Subject: Response to U.S. Nuclear Regulatory Commission Request of October 14, 1999, for Additional Information on the Ground Water Compliance Action Plan for the Salt Lake City, Utah, Title I Uranium Mill Tailings Site

Salt Lake City, Utah GCAP NRC Request for Additional Information (RAI)

U.S. DEPARTMENT OF ENERGY GRAND JUNCTION OFFICE, COLORADO	
Monitor Well Locations Salt Lake City, UT			
<small>DATE PREPARED</small> January 17, 2000		<small>FILE NAME</small> U0084000-01

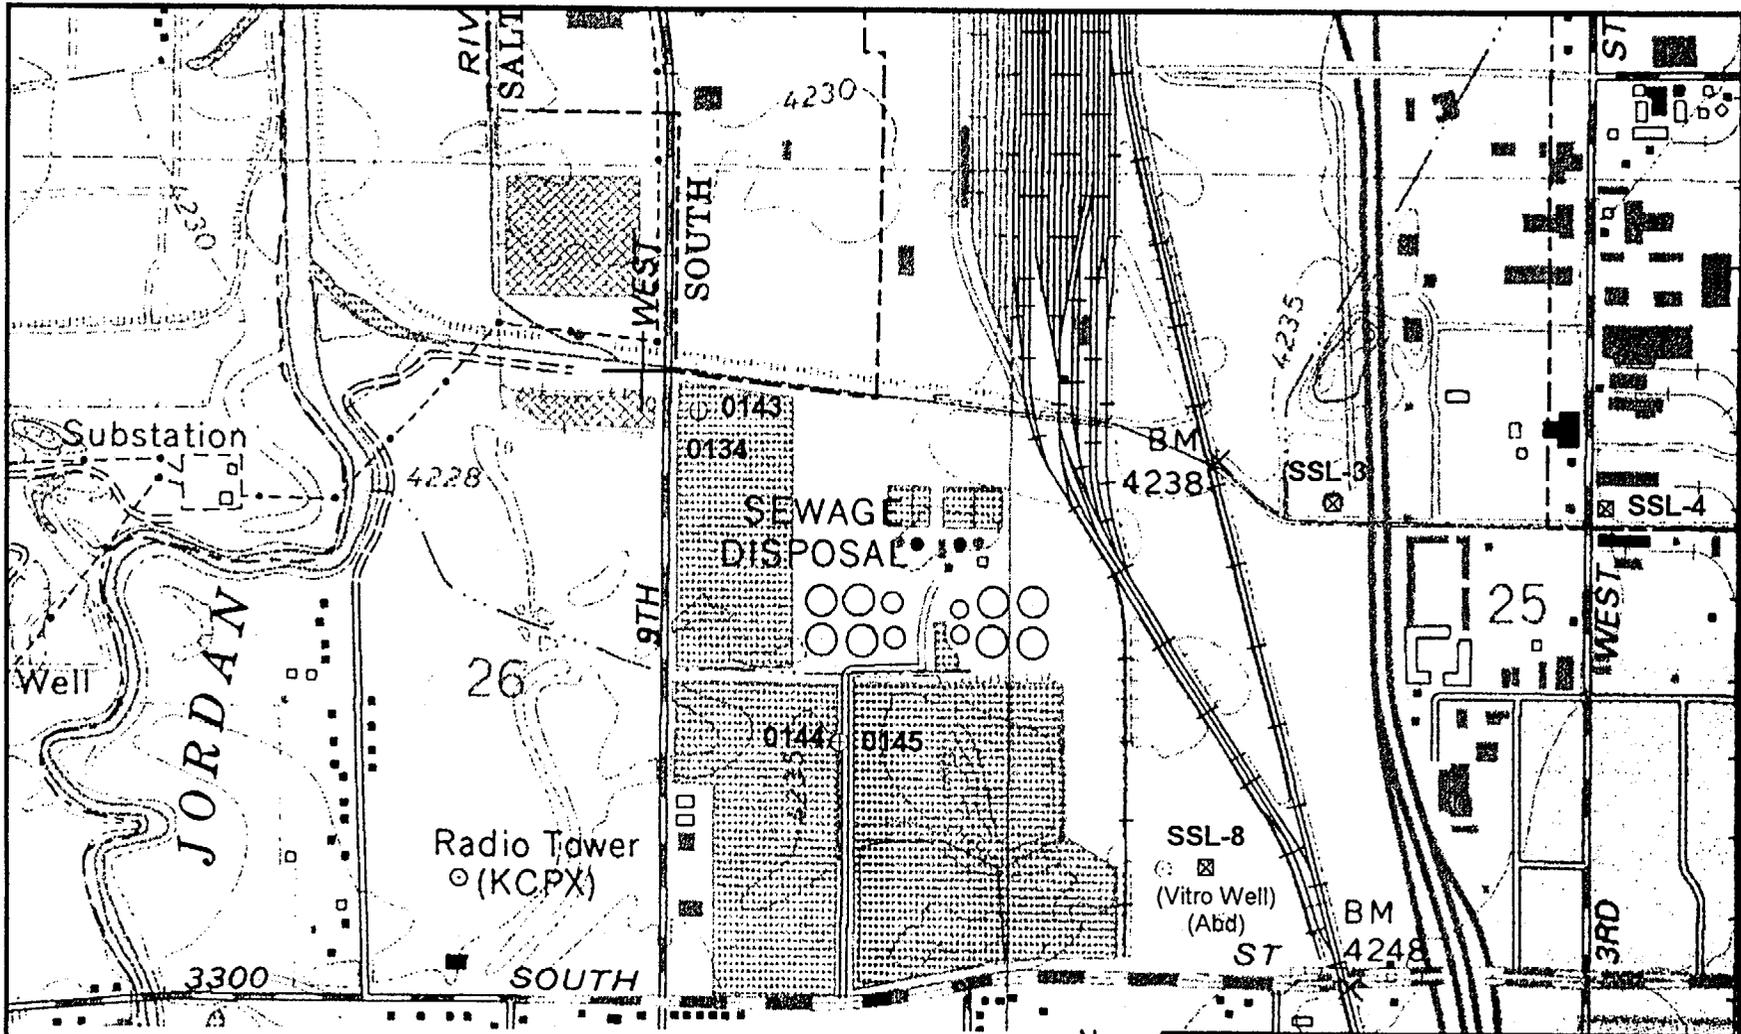
- *Comment 4: Areal photograph of site showing major water supply wells in vicinity.*

The onsite Vitro water supply well (SSL-8) was decommissioned in September 1999. The nearest water supply wells (SSL-3 and SSL-4) are more than one-half mile from the site in a cross-gradient direction (northeast). A modeling study done in 1996 for the City of South Salt Lake (CH2M HILL 1996) showed the delineation (capture) zone for the onsite Vitro well upgradient to the east, and thus not drawing significant ground water from beneath the site. There should be no problem with the potential pumping areas of influence from the more distant wells having any impact in the area beneath the processing site. Locations of nearby water supply wells are shown on the new Figure 2 in the revised GCAP.

Ground water monitoring will be continued at the Salt Lake City site as a best management practice (Table 1 and Figure 2). The primary State concern was possible migration of potentially contaminated ground water in the shallow unconfined aquifer downward into the deeper confined aquifer if the upward vertical hydraulic gradient were to reverse. This will be monitored by measuring ground water levels in pairs of wells completed in the shallow (monitor wells 134 and 144) and deep (monitor wells 143 and 145) aquifers respectively, at two locations onsite and downgradient (Figure 2). DOE will also monitor ground water quality annually in the two wells in the shallow unconfined aquifer (monitor wells 134 downgradient and 144 onsite) to ensure that concentrations of COPCs (molybdenum and uranium) continue to decrease. If there is an indication that the vertical hydraulic gradient is reversed, ground water in the deep confined aquifer will be sampled and analyzed to ascertain that no site-related constituents migrate into the deeper aquifer. Baseline monitoring in October 1999 shows that there is a strong upward vertical hydraulic gradient and that concentrations of uranium and molybdenum in ground water in the deeper confined aquifer are near or below the detection limit (Attachments G and H).

As an added precaution against potential contamination of ground water in the deeper aquifer the Vitro water supply well in the southeast corner of the site was decommissioned in September 1999 (Figure 2 and Attachment H). The well has been in place for a number of years and the integrity of the annular seal was unknown. The well belonged to the City of South Salt Lake who was not using the well and had no plans to do so. The City of South Salt Lake granted DOE authorization to decommission the well.
